City of Fredericksburg

Planning and Zoning Meeting Agenda
Wednesday, May 6, 2026 ~ 5:30 PM
New City Hall at East Campus
2818 E. U.S. Hwy. 290
Fredericksburg, Texas 78624

RE: SP-2602, Review Comments for the La Posada Site Plan located at 111 FM2093, Fredericksburg, Texas, 78624

RE: SP-2603 Review Comments for the Bethany Lutheran Site Plan located at 110 West Austin,
Fredericksburg, Texas 78624

PLAN NORTH
1
ELECTRICAL POWER SITE PLAN
SCALE: 1" = 30'-0"

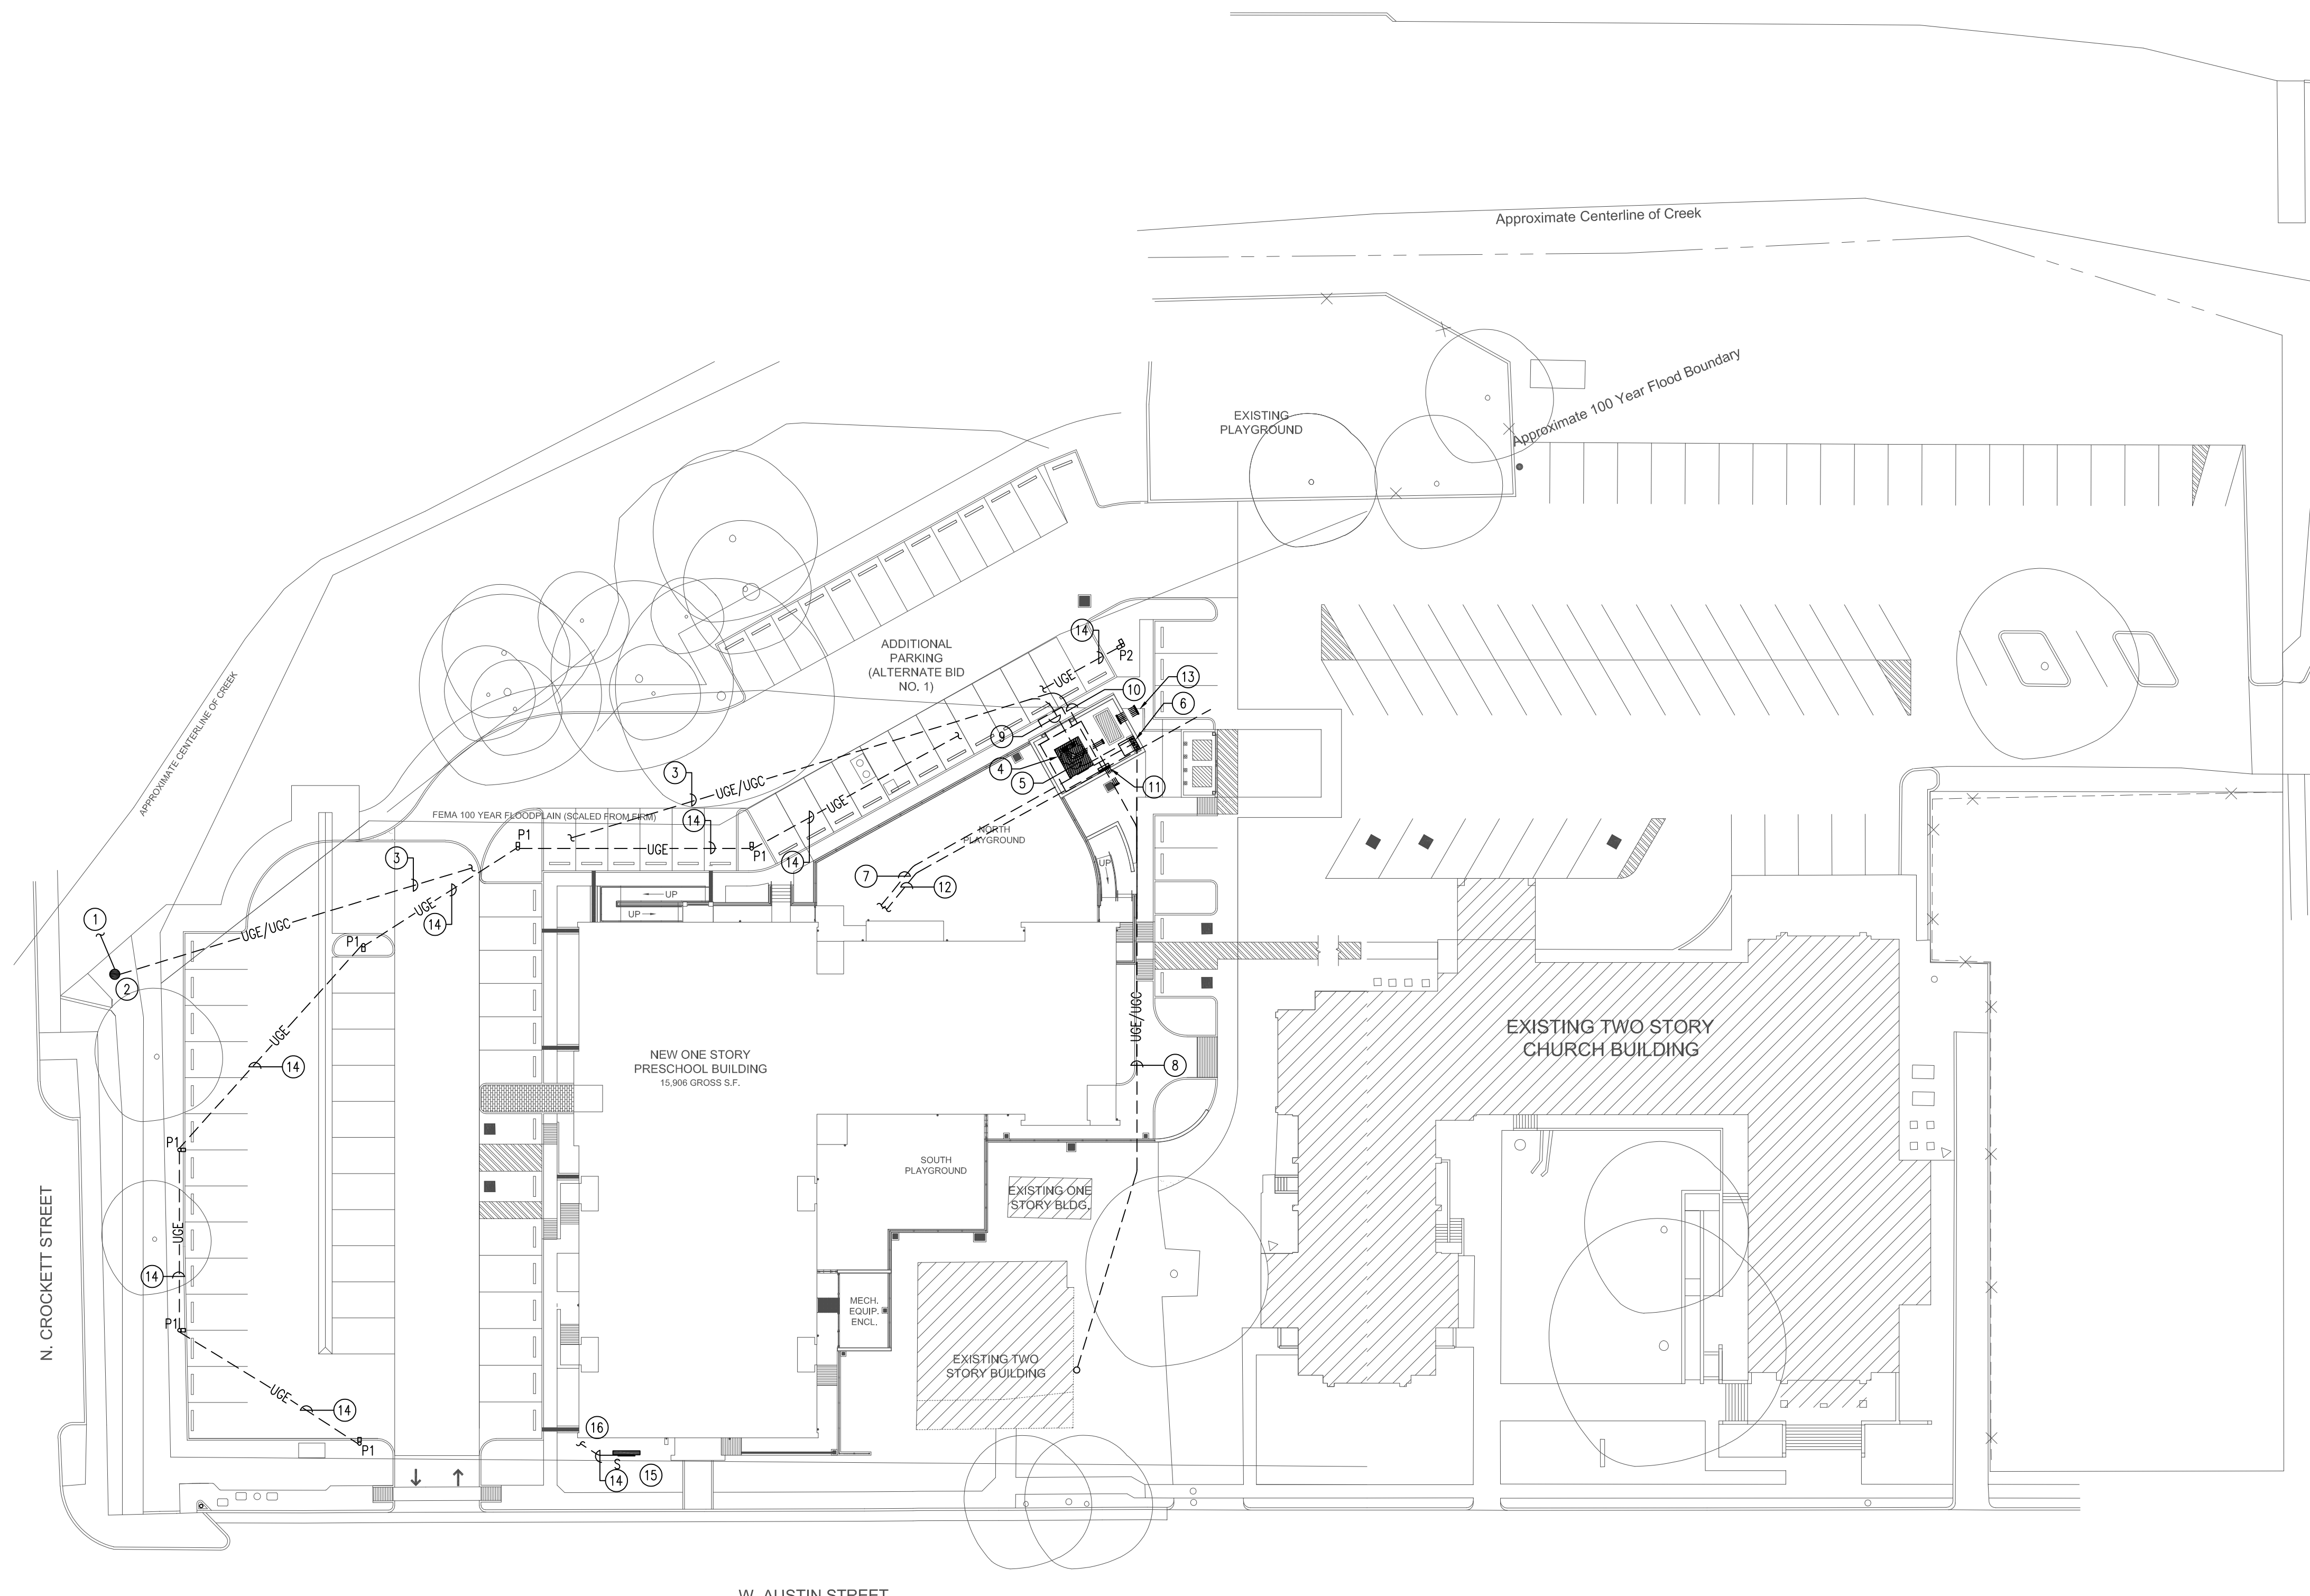
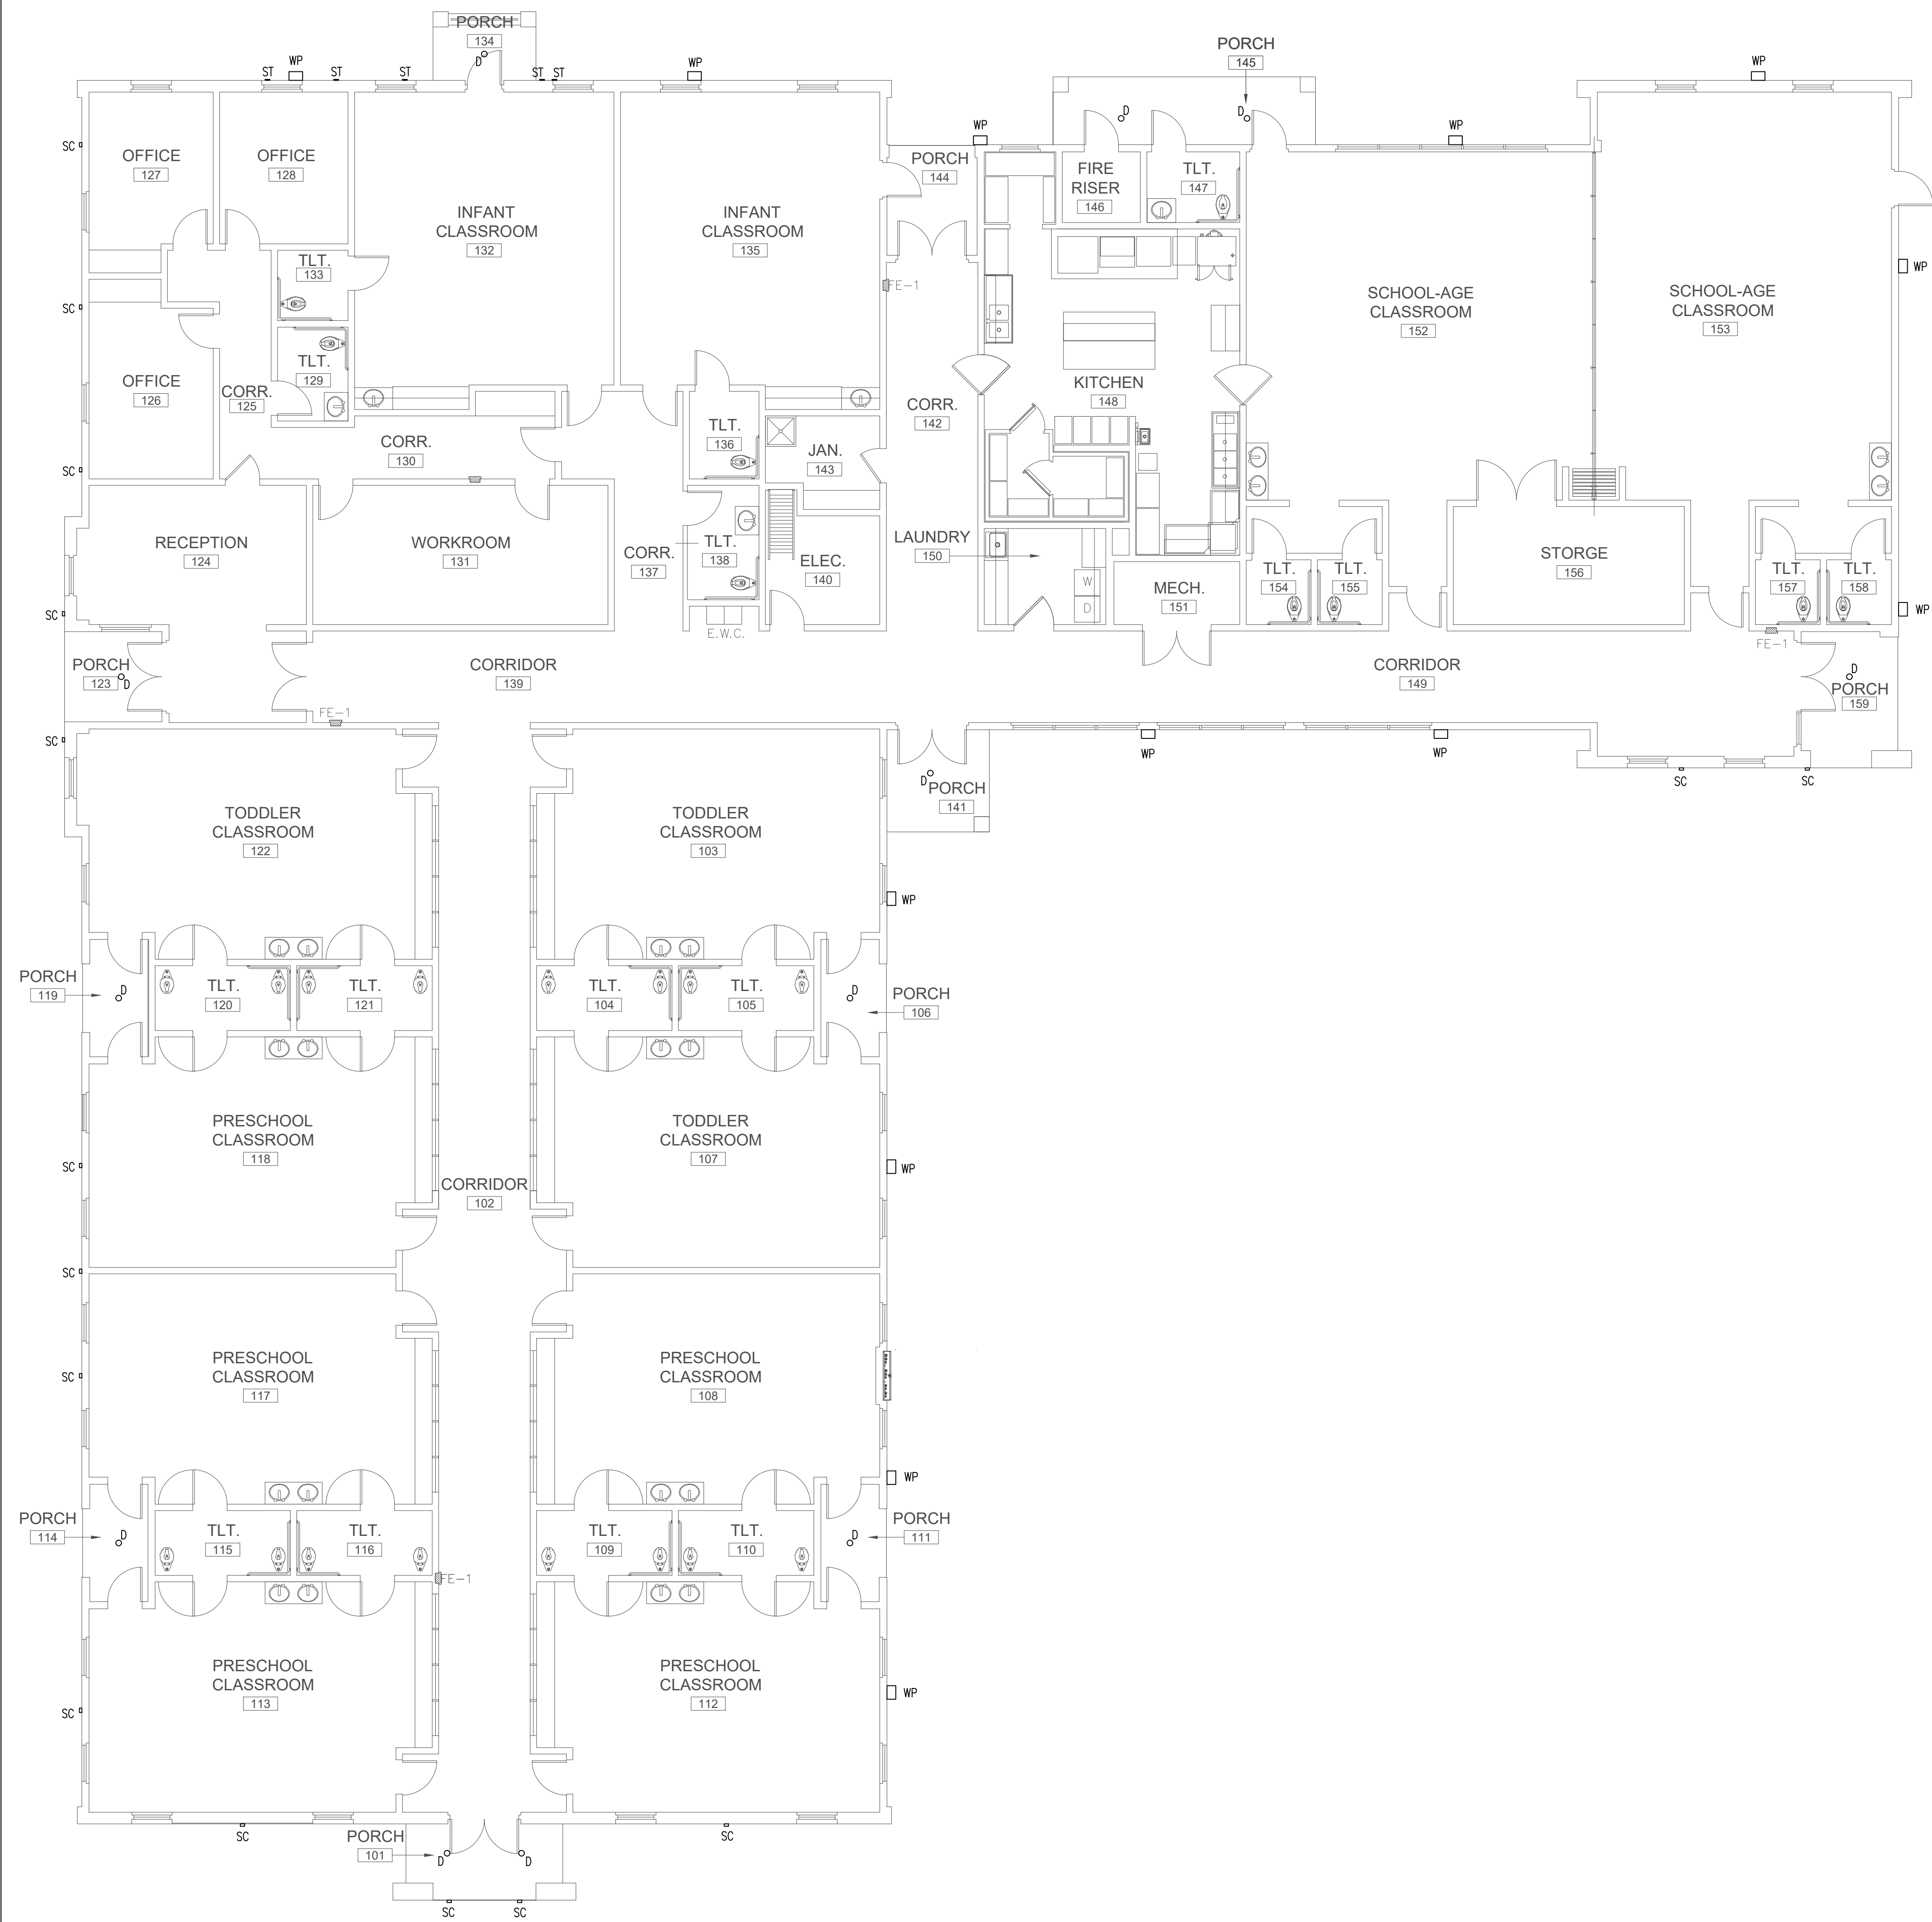
Response:
One exterior ground sign is proposed, and it has been added to the attached updated Site Development drawings.
3. **Comment:**
Submit proposed exterior lighting, including fixture type. Article XV – Outdoor Lighting.

Response:
See attached “Electrical Power Site Plan” and related light fixture schedule.
4. **Comment:**
The building will require Historic Review Board approval prior to building permit submittal.

SHEET TITLE
A Replat of Lot 1R-1

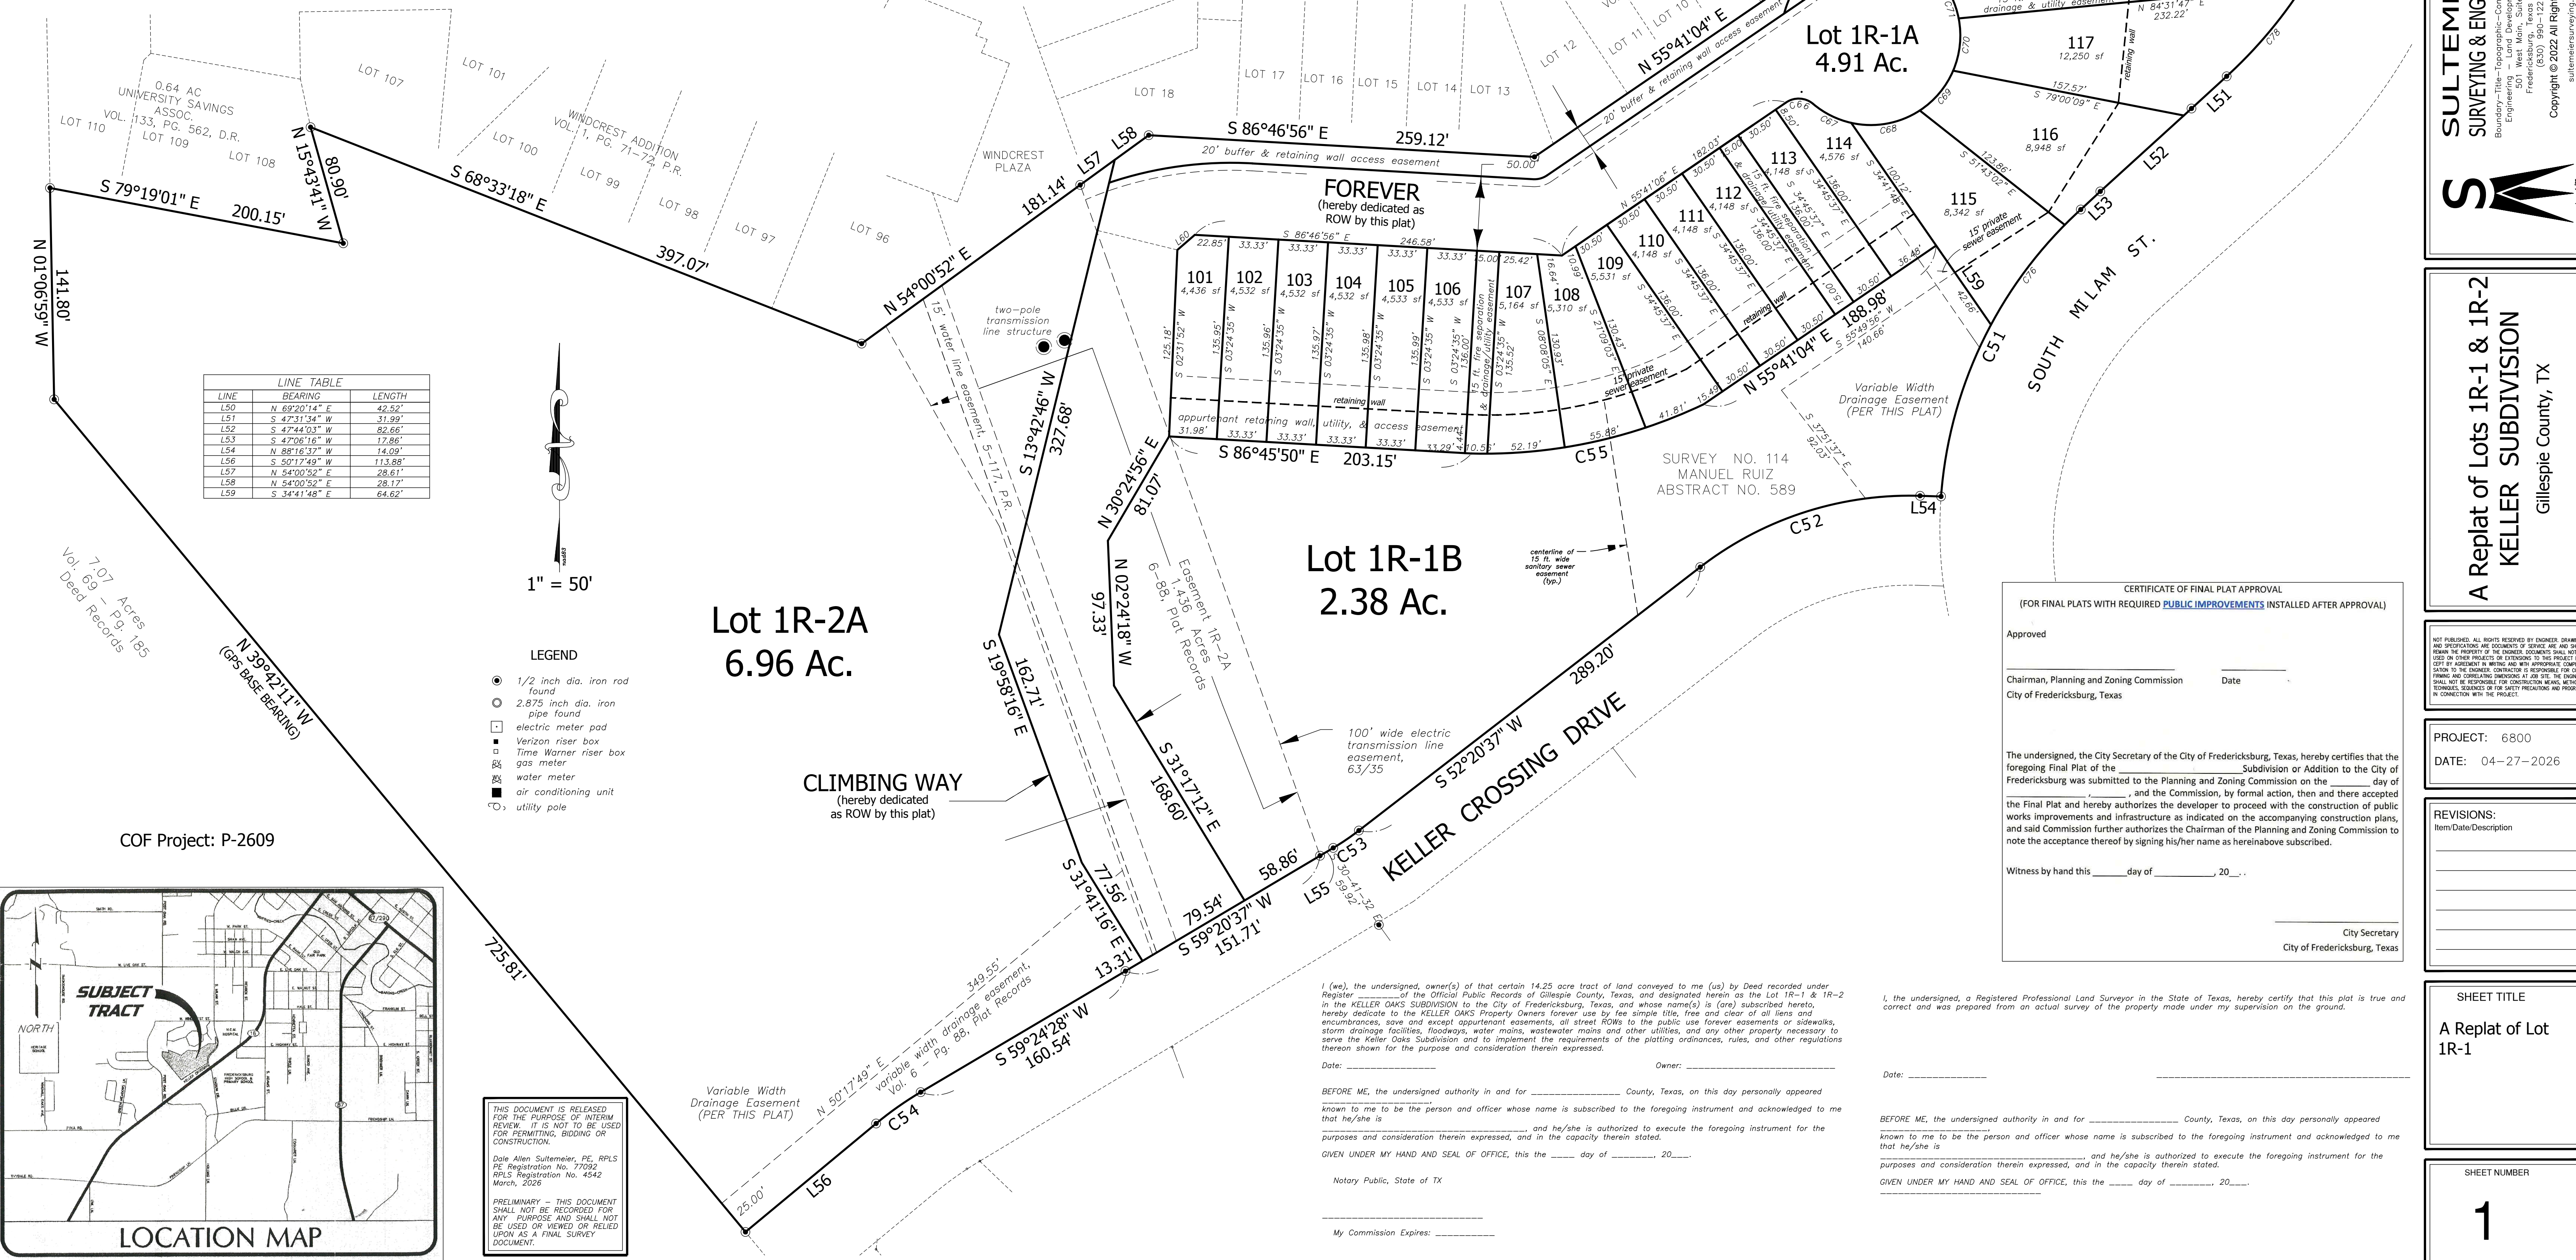
- Modification of the Cul-de-Sac not to encroach into the 20' Buffer
- Label Width of South Milam Street
- Incorporate Drive Street
- Approval of Civil Constriction Plans
- Preliminary Utility Plan be administratively approved Prior to Construction
- Notes Incorporated to specify maintenance of dedicated easements
- Payment of Park Dedication fees
- Clarification of outlot north of proposed lot 118.

- Add P-2609 to plat
- Name of plat must be "Replat of Keller Subdivision, Lots 1R-1 and 1R-2, Creating Lot 1R-1A, Lot 1R-1B and Lots 101 through 119." Remove Crown Point name.
- Add date of preparation
- Label widths of Keller Crossing Drive and South Milam St.
- Identify 7,744 sq. ft. lot on upper right-hand corner of plat
- Why are Climbing Way and Forever labeled as access easements? Will they be private roads?
- You are missing multiple signature blocks including City and County.

1. The cul-de-sac should not encroach on the 20-foot buffer/retaining wall easement, please address this.
2. A preliminary utility plan showing water, sewer and electric , to determine what utility easements will be needed.
